TECHNICAL SERVICE BULLETIN

CHECK ENGINE LIGHT WITH FAULT CODE P2096-00

No: TSB-26-13-001

2026 Outlander with 4B40 Gen 2 Engine (Cut-off VIN JA4J4VAB1TZ053645)

REPROGRAMMING PROCEDURE

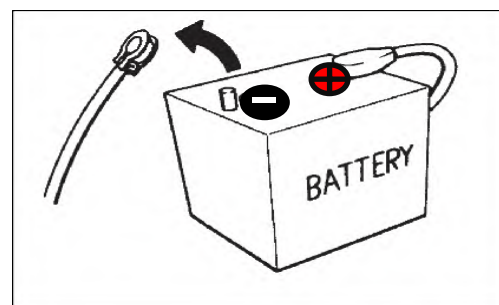
Ensure that the **MUT3-SE software version is #994 or higher** prior to proceeding. Perform the software update to the ECU and clear the Diagnostic Trouble Codes (DTCs).

Model	Data No.	New HW Part No.	New SW Part No./Ver.	Target HW Part No.	Remarks
Outlander	23761W41.9PN	-	23761W419P	23703W013P	2WD CRUISE CONTROL
	23761W42.0PN	-	23761W420P		2WD ADAPTIVE CRUISE CONTROL
	23761W42.1PN	-	23761W421P		2WD MI-PILOT Assist
	23761W42.2PN	-	23761W422P		4WD CRUISE CONTROL
	23761W42.3PN	-	23761W423P		4WD ADAPTIVE CRUISE CONTROL
	23761W42.4PN	-	23761W424P		4WD MI-PILOT Assist
